## ITEM FOR PUBLIC WORKS SUBCOMMITTEE OF FINANCE COMMITTEE

#### 76TI – Bus-bus interchanges on Tuen Mun Road

Members are invited to recommend to Finance Committee to increase the approved project estimate of **76TI** by \$43 million from \$162.3 million to \$205.3 million in money-of-the-day prices.

圖則名稱 drawing title  
 工務計劃項目第76TI號 - 屯門公路巴士轉乘站 - 平面圖  
 PWP ITEM NO. 76TI - BUS-BUS INTERCHANGES ON TUEN MUN ROAD - LAYOUT PLAN

圖則編號 drawing no.  
 HMW6076TI-SK0036

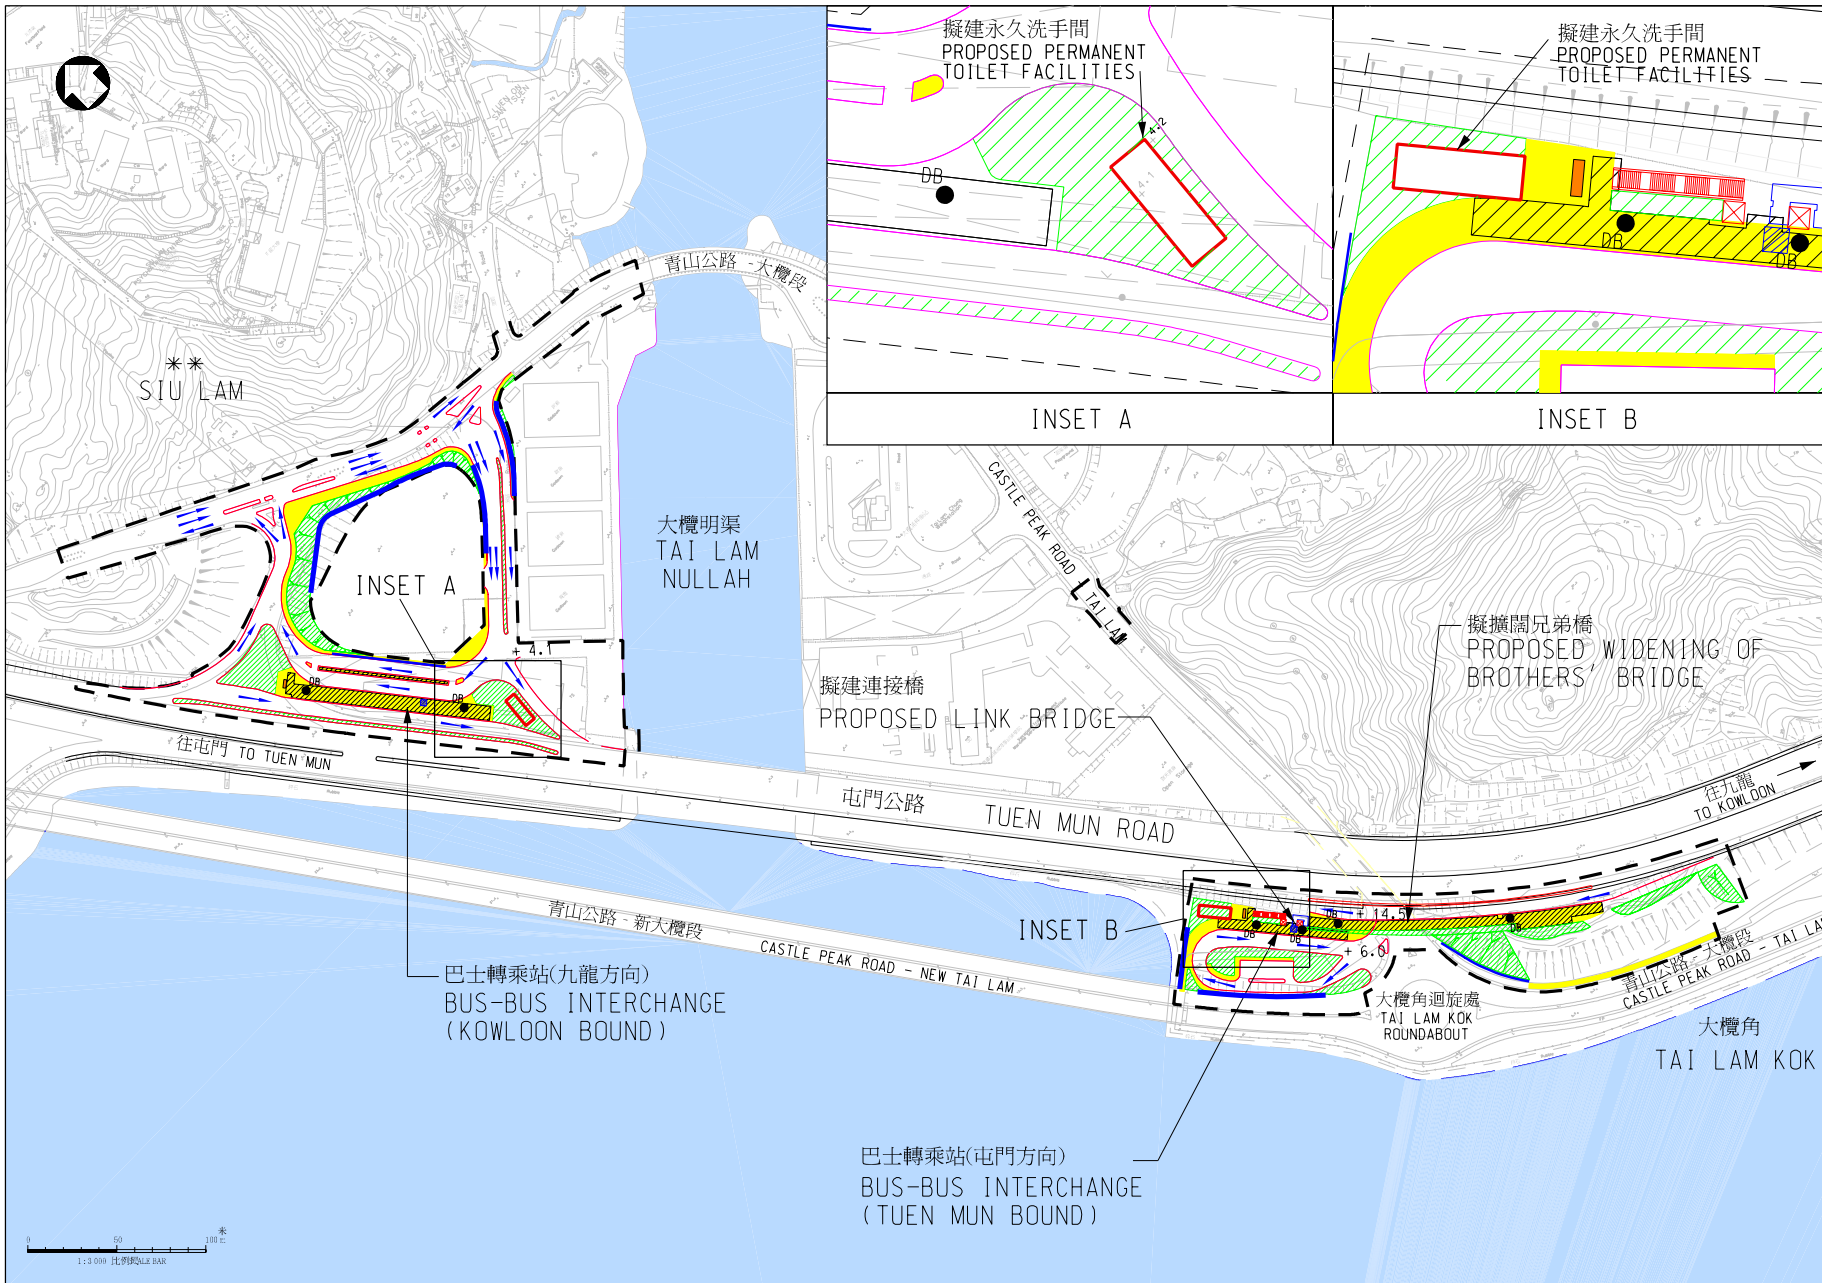
10. In view of the strong public demand for permanent public toilet facilities at the TMR BBIs as well as the geographical location of the BBIs and the lack of toilet facilities in the vicinity, we propose to expand the scope of **76TI** for providing permanent toilet facilities at a cost of \$20.2 million in MOD prices. The proposed locations of the permanent toilet facilities are as shown in Enclosure 1.
